# Royal Far West Concept Plan - Modification 1

Section 75W Modification Assessment  
MP 10\_0159 MOD 1

April 2022

Figure 11 | Axonometric site plan of approved concept plan envelope (left) and proposed concept plan envelope (right) (Source: Proponent's Response to Submissions)

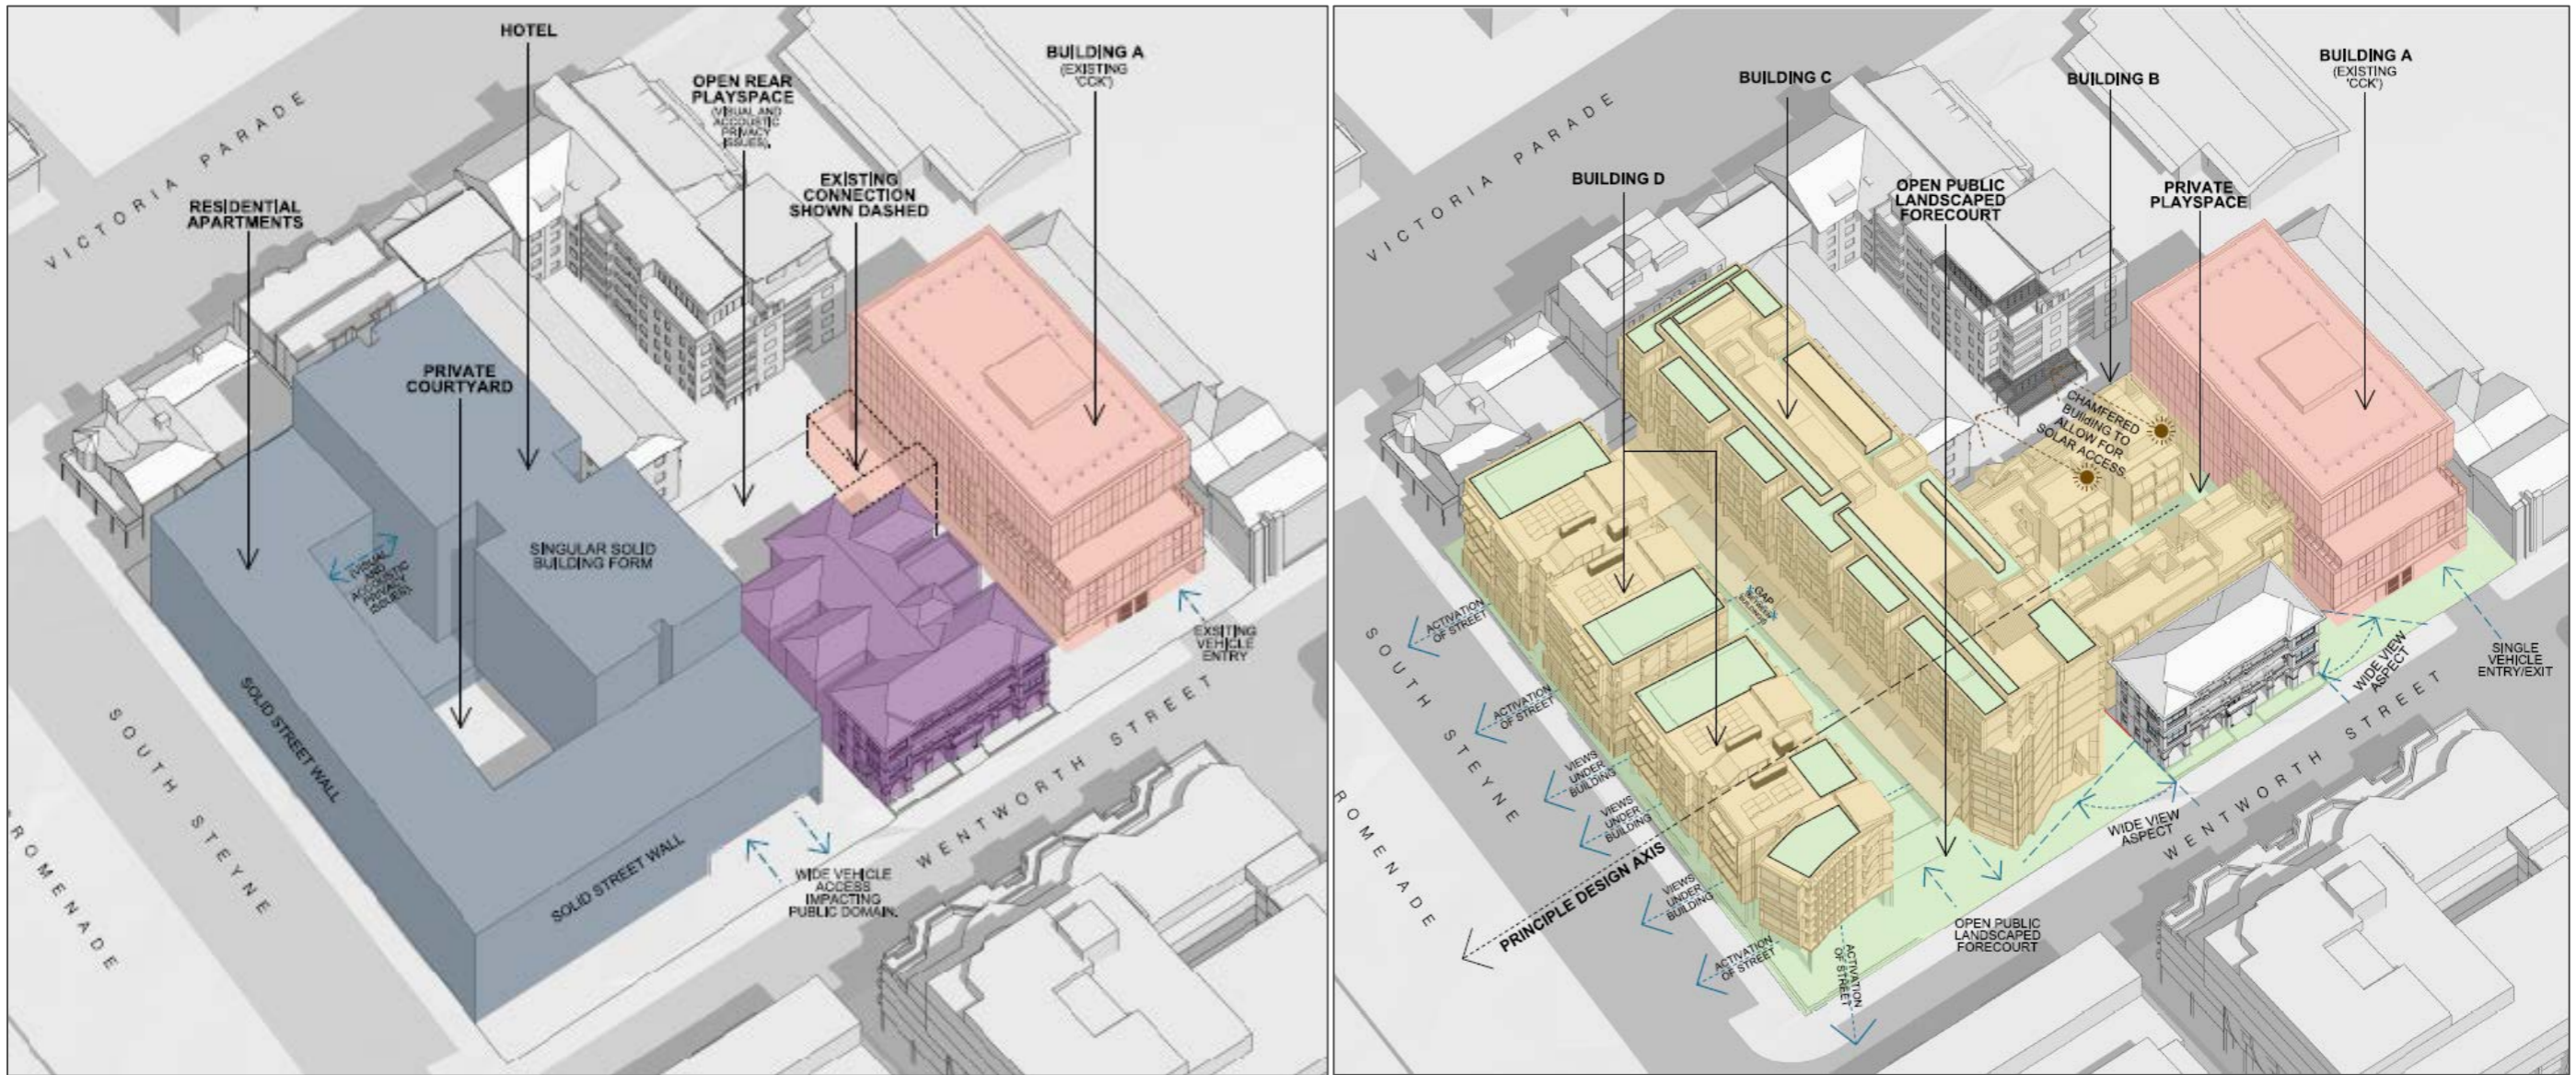
The modification request seeks approval to amend the site boundary and approved building envelopes, including changes to the layout, height, floor space, land uses and locally listed Drummond House. The proposal (as amended in response to submissions) is summarised in **Table 2** and **Figures 10** and **11**.

**Figure 12** | The site, with Building D shown in shown in red in front of Building C, compared to other buildings along the Manly foreshore (Source: Proponent’s Response to Submissions)

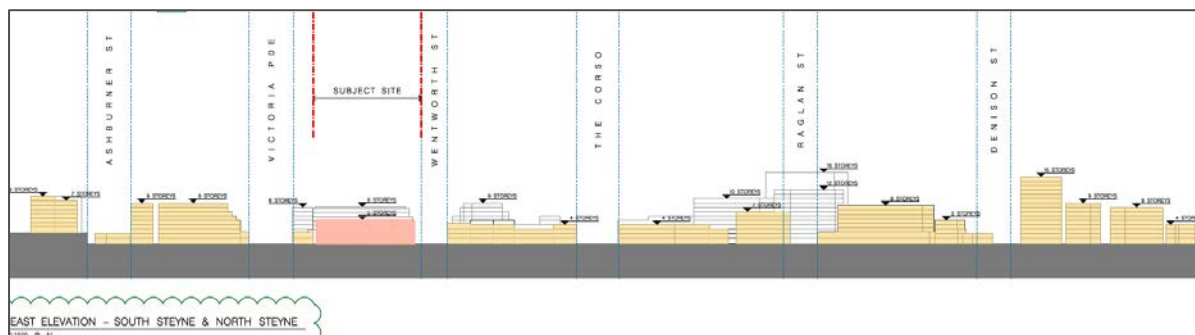
- the additional height above the existing approved height of RL 31.15 is minor (being 1.2 m or 3.8%) and imperceptible when viewed from the surrounding public domain
- it would sit comfortably with the heights of other buildings along the Manly foreshore (**Figure 12**)

However, the Department agrees with Council that any structures on the roof, including lift and stair access, pergola, landscaping and sunshades, above RL 32.35 may not be adequately integrated into the design and have the potential to be visually dominant when viewed from the surrounding public domain.

**Figure 13 |** Comparison of the Wentworth Street elevation, with the approved on the left and proposed on the right (Source: Proponent's Response to Submissions)

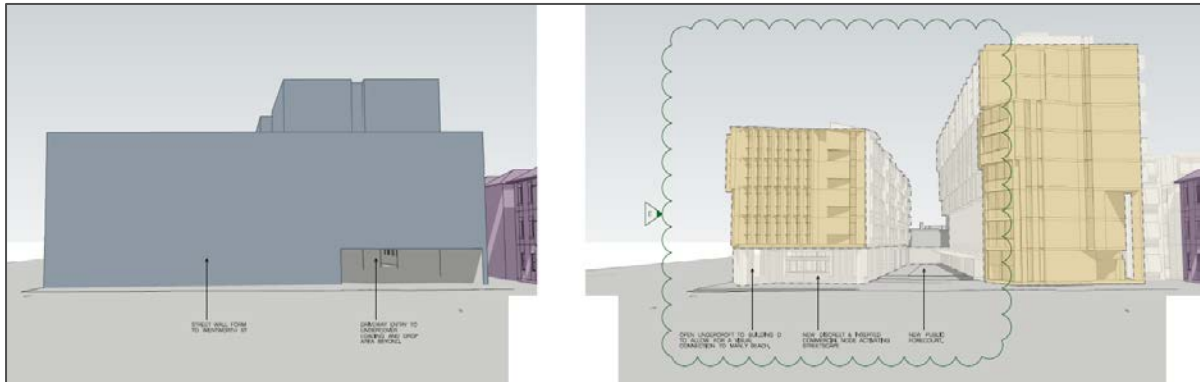
The Department supports the revised setbacks along Wentworth Street as:

- the proposal is capable of exhibiting design excellence (**Section 5.1**), noting the Panel supported the revised form and massing and minor incursions into the 6 m setback along Wentworth Street
- the combination of removing built form fronting Wentworth Street and providing a 14.5 m gap between Buildings C and D results in an improved built form outcome, by providing two taller and thinner building forms with a clear separation, rather than a lower longer built along Wentworth Street (**Figure 13**)
- the reduced setback would not have any significant impacts on private views from 331/25 and 332/25 Wentworth Street, when compared to the concept approval (**Section 5.3.2**).

**Figure 14 |** Comparison between the approved layout for Building B (left) and proposed layout (right) (Source: Proponent's Response to Submissions)

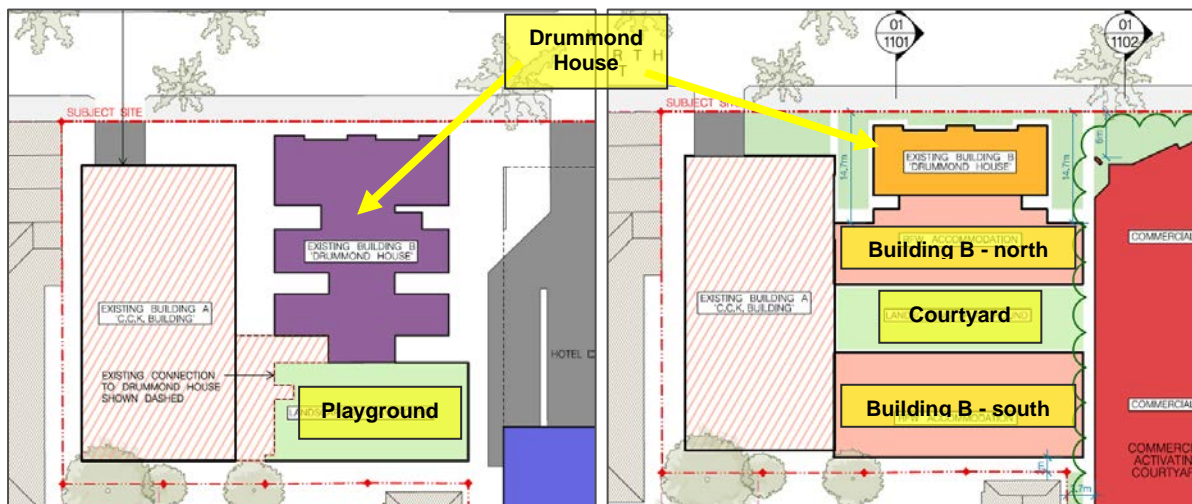
Concern was raised in public submissions that the new southern Building B envelope, together with the removal of the approved open space behind Drummond House, may adversely impact neighbouring residential amenity (such as solar access, views and privacy) to 25-27 and 29 Victoria Parade.

In response, the Proponent reduced the height of this southern Building B envelope to improve solar access to properties to the south, as summarised in **Table 8**.

**Figure 15 | Section showing proposed heights of Building B (in pink), with the existing buildings on the site shown in orange dashed and area where existing buildings are higher and closer than the proposed envelope in blue dash (Source: Proponent’s Response to Submissions)**

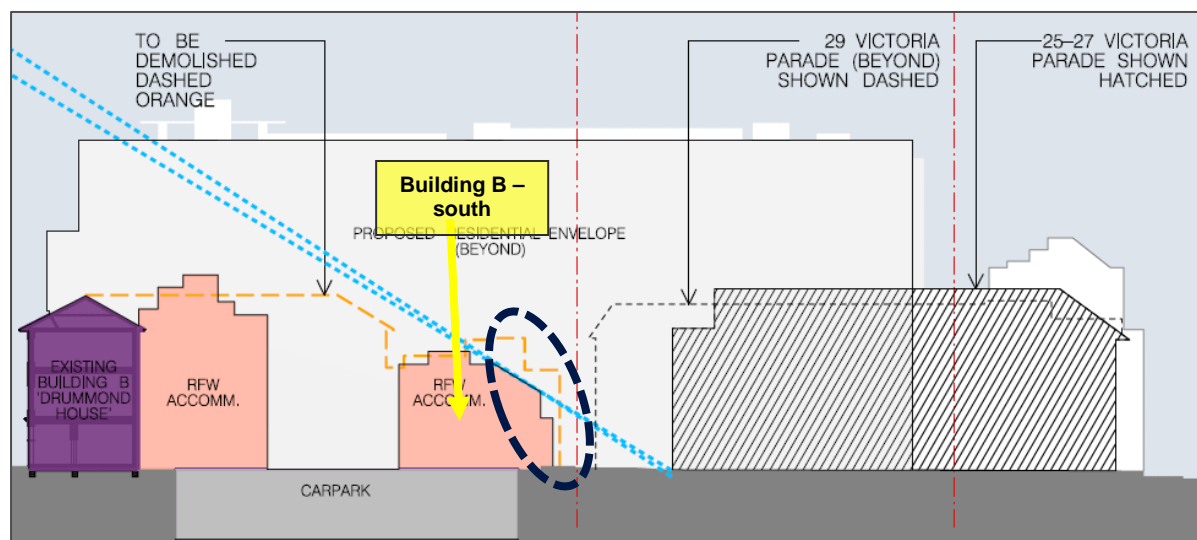
- the maximum height of the southern envelope (being RL 13.65 reducing to RL 11.32 at the southern boundary) provides an appropriate scale transition and reasonable amenity to 25-27 and 29 Victoria Parade
- the southern envelope would not cause unreasonable overshadowing to adjoining properties (**Section 5.3.1**) and view impacts from the public domain and private properties (**Section 5.3.2**)
- the maximum height of the southern envelope (at approximately 10 m above ground level) complies with the maximum height control in the Manly LEP (being a maximum height above ground level of 14 m)
- the current building in this location (which could be retained by the Proponent should it wish) is higher than the proposed envelope, is closer to the boundary and contains an accessible roof terrace that overlooks adjoining properties (**Figure 15**).

However, the Department is concerned that the lift core (at RL 13.59), planter / podium (at RL 14.72) and access stair structures (with no RL) on the southern envelope are larger than they need to be to service the development and are not visually integrated into the building design. Further, these features result in unnecessary overshadowing of some north facing windows of 29 Victoria Parade.

**Figure 16** | Building D envelope, showing the maximum height compared to the concept approval (in blue dash), residential levels in yellow, commercial level in red and the undercroft space (Source: Proponent’s Response to Submissions)

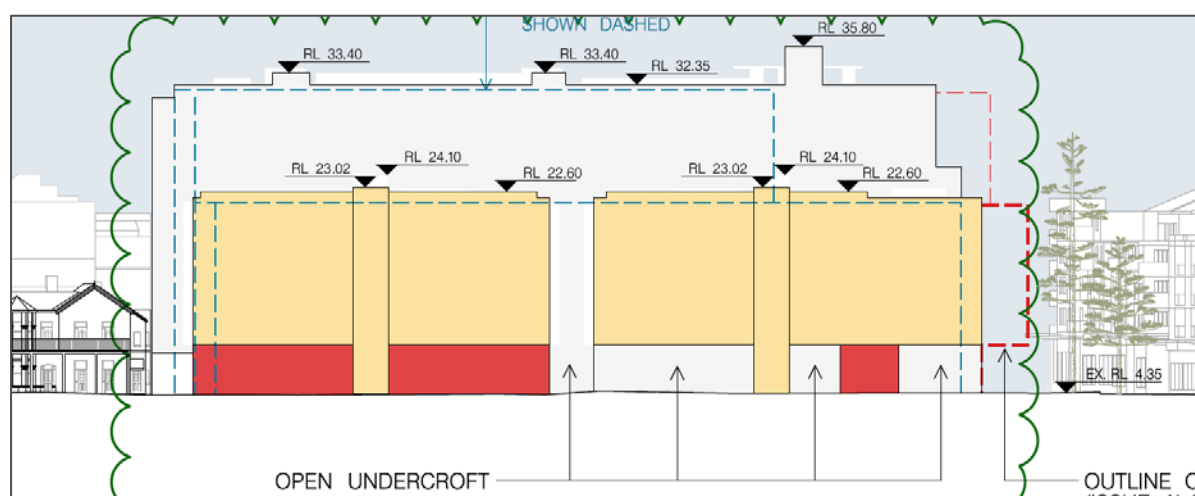
The proposed Building D (**Figure 16**) envelope comprises two building envelopes of 30 m to 34 m in length fronting South Steyne, with a 4 m separation, and approximately 18.5 m in width. The proposed Building D envelopes have a height of RL 22.60, with RL 23.20 to the lift (at the buildings rear) and RL 24.10 to the stair core.

While slightly taller (0.9 m) than the approved envelope (excluding the stair and lift cores), the Department is satisfied the proposed envelope is generally consistent with the concept approval and the proposed height would sit comfortably with the height of other buildings fronting Manly Beach (**Figure 12**). Further, the building envelope is well articulated through the 4 m separation and further gaps provided in the South Steyne frontage.

**Figure 18 |** Shadow diagrams illustrating solar access impacts to Manly Beach at 5pm (top) and 6pm (bottom) in mid-summer (Base source: Proponent’s Response to Submissions)

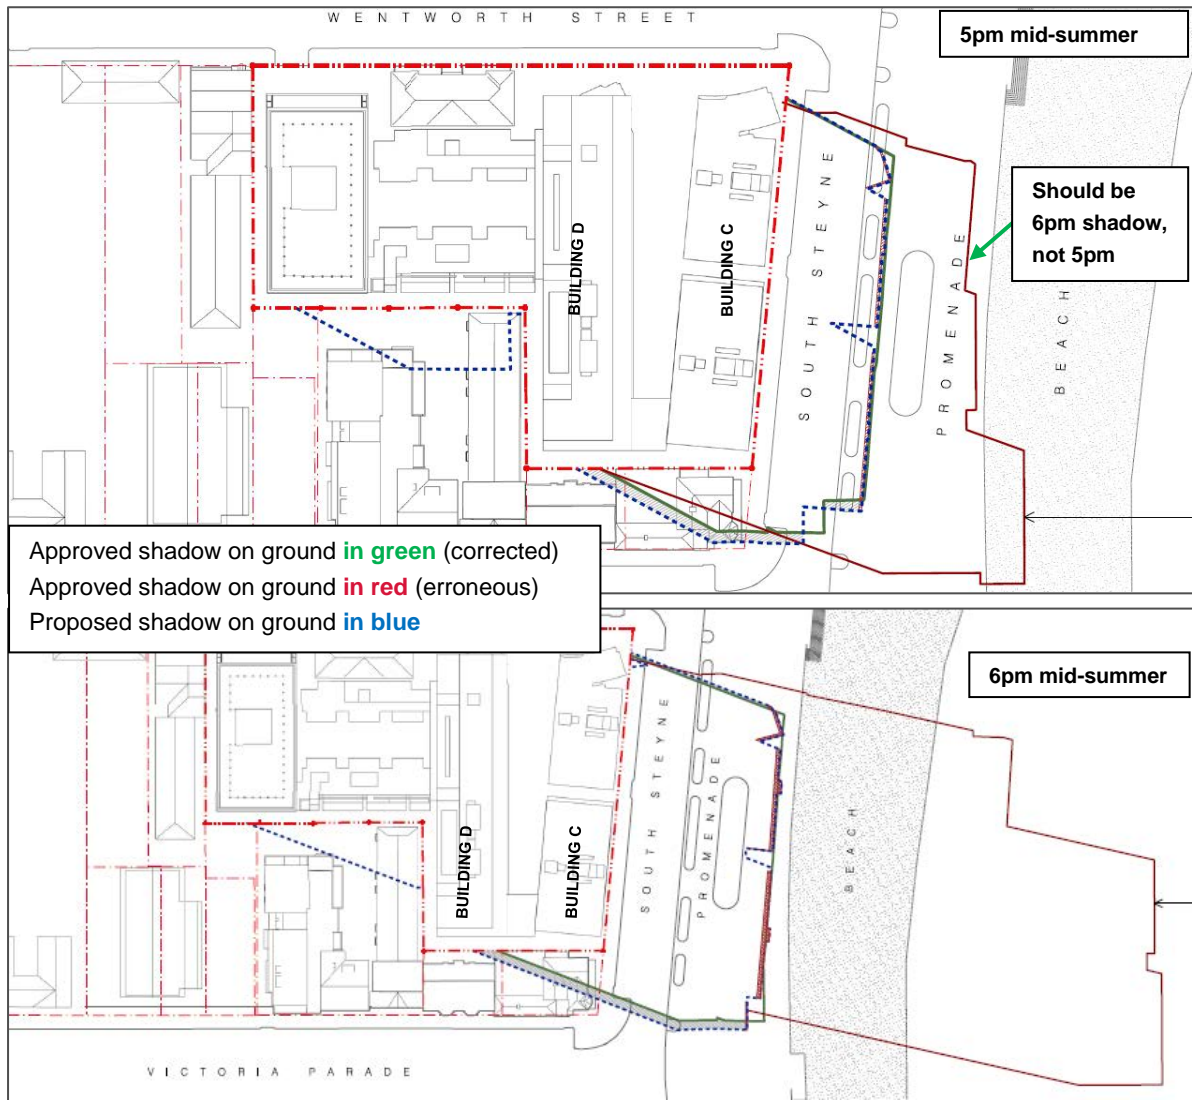
The Proponent's shadow analysis shows that the revised Building C and D envelopes (including height increase and lift cores) will not overshadow Manly beach before 6pm in mid-summer (**Figures 18** and **19**). It also shows that the proposal will result in some minor additional overshadowing to the promenade between 5pm and 6pm in mid-summer when compared to the concept approval.

The Department's expert, Walsh Analysis, assessed the difference in overshadowing between the original concept approval and proposal at mid-summer (21 December) using the Proponent's model and advises that there would be no overshadowing of Manly Beach before 6pm and no major increase in overshadowing of the public domain.

**Figure 20** | Shadow diagrams illustrating solar access impacts to Manly Village Public School between 8am and 8.45 in mid-winter (21 June) shaded red (Base source: Proponent's Response to Submissions)

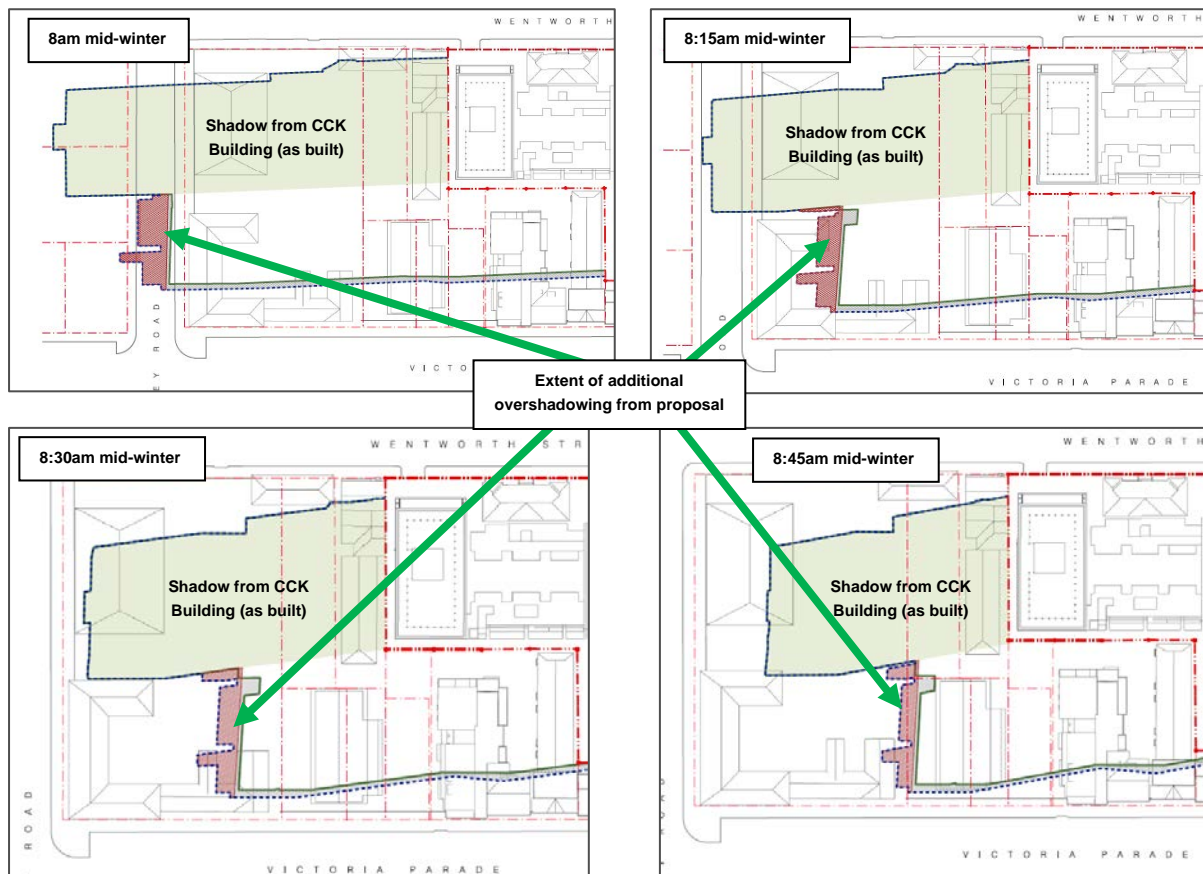
The Proponent has provided shadow diagrams showing that, when compared to the concept approval, the proposal would result in further overshadowing of the school between 8am and 9am in mid-winter (**Figure 20**). At 8am in mid-winter an additional shadow is cast onto Darley Road, which moves east over the school buildings and courtyard (with sunshades and large mature trees) until approximately 9am. The Proponent contends this impact is minor and large areas of the playground will continue to receive solar access throughout the day (**Figure 21**).

The Department's expert notes that the proposed modifications have a very small impact on the school at 9am in mid-winter and by 9.30am there is no increase in overshadowing. At the equinox and in mid-summer, there is no increase in overshadowing between 9am to 3pm. The expert notes that the small increase in overshadowing is reasonable as the area is not heavily used at that time.

The Department accepts the expert advice and is satisfied the additional overshadowing of the school is negligible given it only affects a small area of the school which is already overshadowed by other structures and mature trees and no shadows would be cast over the school past 9.30am in mid-winter (**Figure 20**).

**Figure 22** | Comparison of private view impacts from 5/29 Victoria Parade as a result of the revised proposal (right) compared to the concept approval (left) (Base source: Proponent's Response to Submissions)

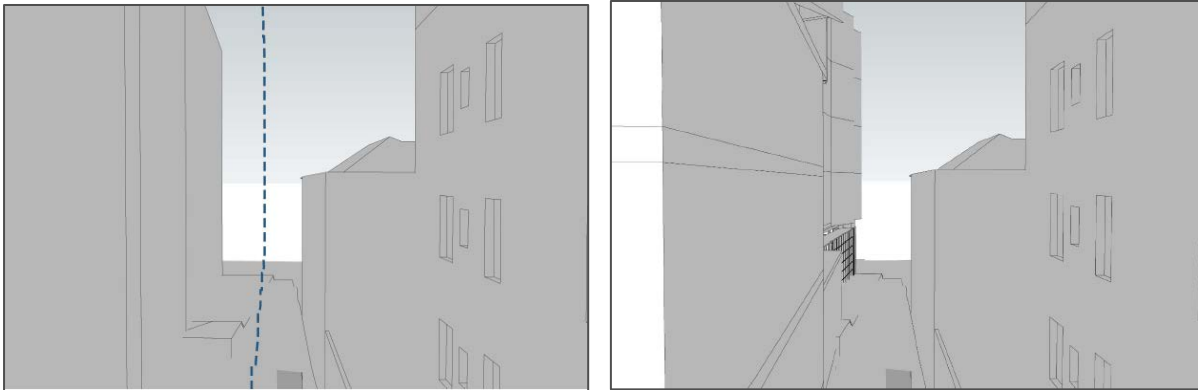
- the Building C and D envelopes have been revised in response to submissions to increase the setback to 31 Victoria Parade and 15 to 16 South Steyne, which maintains private views from 5/29 Victoria Parade to Manly Beach (**Figure 22**)

**Figure 25 |** Building separation distances within the site and to adjacent residential buildings (Source: Proponent’s Response to Submissions)

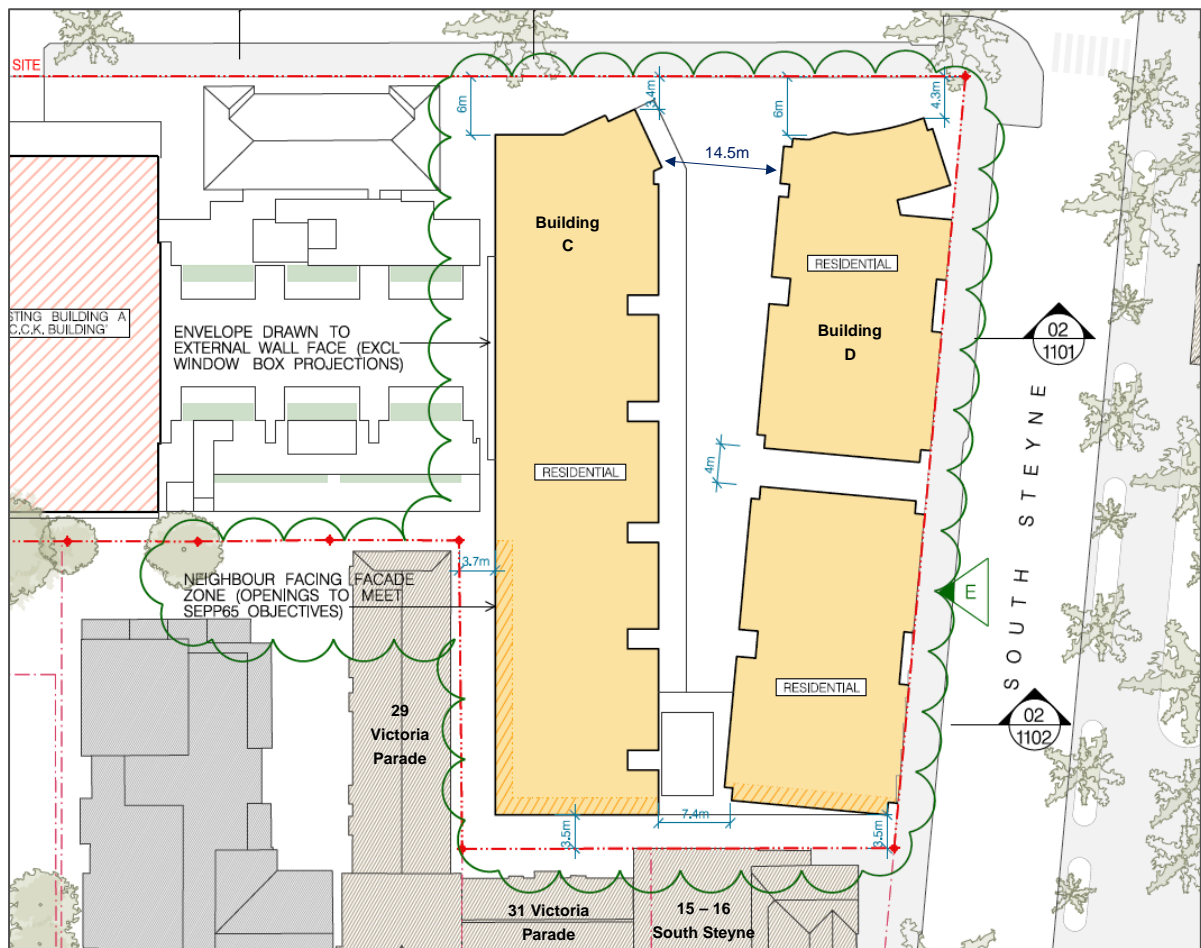
The Proponent contends that while the proposal does not comply with these numerical standards (design criteria), future DAs can include a number of design solutions that are capable of complying with the objective (being to achieve a reasonable level of external and internal privacy). These design solutions include locating residential apartments at varying heights in Buildings C and D (**Figure 25**), to avoid looking directly into adjacent residential apartments, and providing privacy screens adjacent to neighbouring apartments.

The Department acknowledges that the proposed building separation distances are less than those required in the ADG. However, the Department is satisfied that the detailed building design within the envelopes can achieve adequate visual privacy, for the following reasons:
